DESCRIPTIVE REPORT

Registry No. **H-10967**

General Locality **TONGASS NARROWS**

Revisions Compiled During Office Processing and Certification

MapInfo Window in ASL-6 Workspace, showing charted location of piling not found in survey

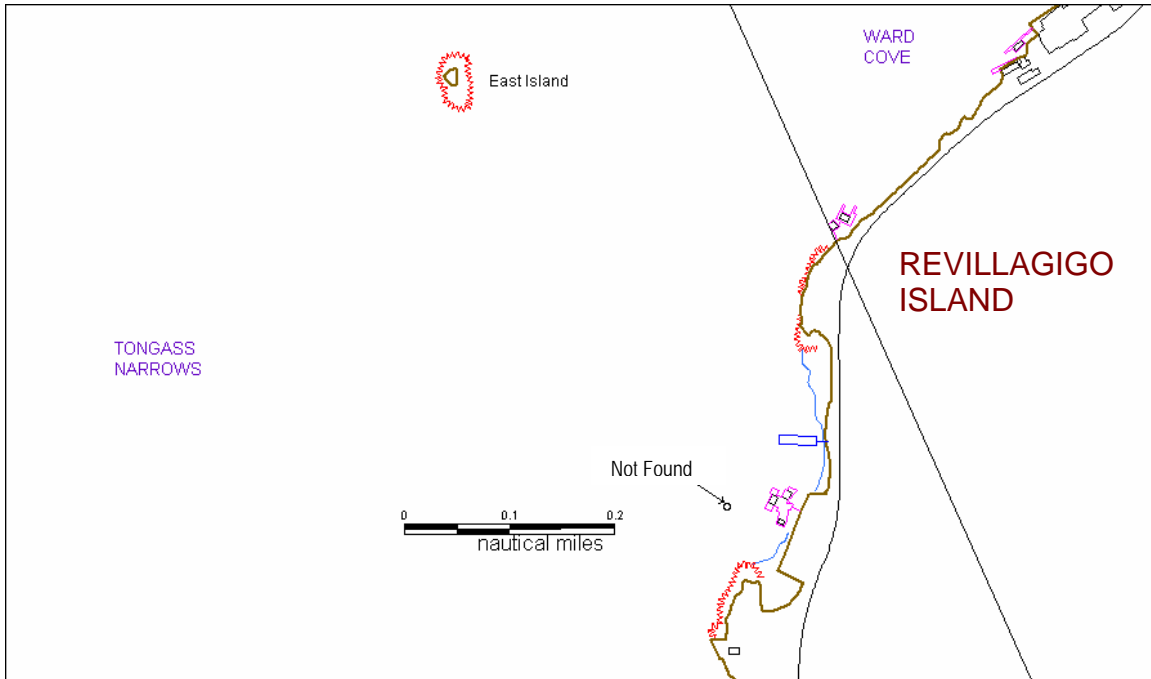
Two nearshore structures, shown in Chart 17428 and ArcInfo Coverage file “piles.e00,” were not found at charted positions. The first was a piling at latitude 55° 23’ 21.4749” north and longitude 131° 44’ 17.8512” west.⁶⁰

⁶⁰ Concur. Delete pile shown on Chart 17428 maintenance raster at Latitude 55/23/21.4749N, Longitude 131/44/17.8512W.

MapInfo Window in ASL-4 Workspace, showing charted location of piling not found in survey

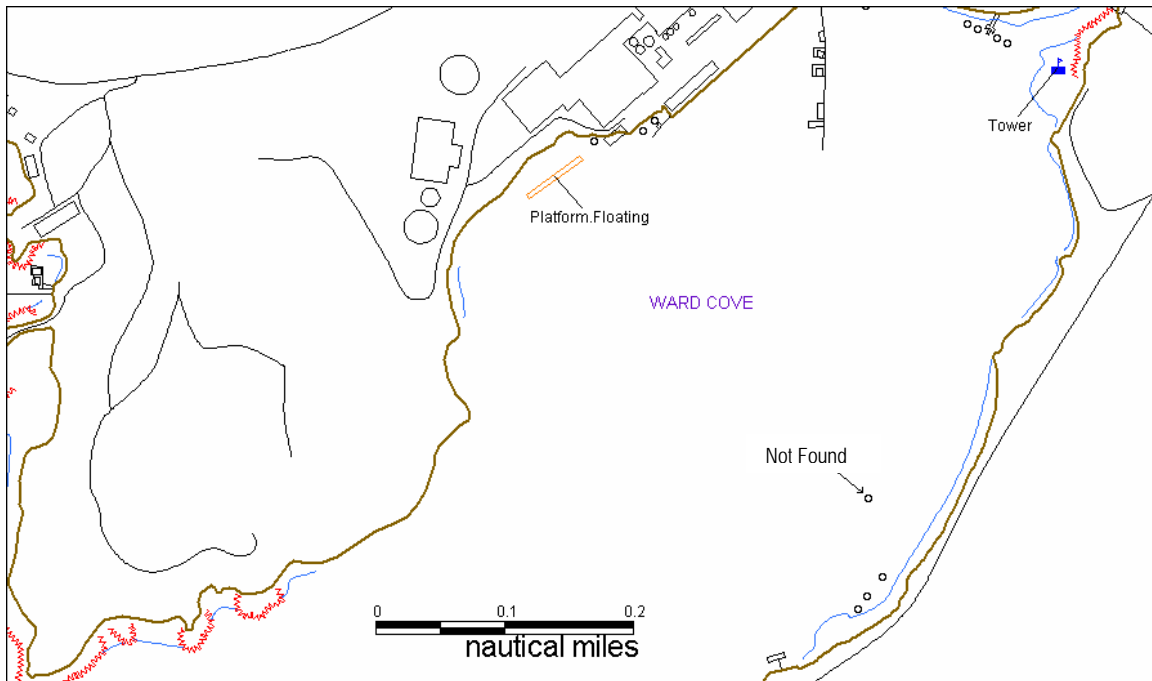
The second item not found was a piling at latitude 55° 24’ 3.4901” north and longitude 131° 43’ 24.4913” west.⁶¹

The survey team's search of the area failed to show any structures at or near the given positions. Further investigation of multibeam data in Caris indicated no submerged pilings at these positions.⁶²
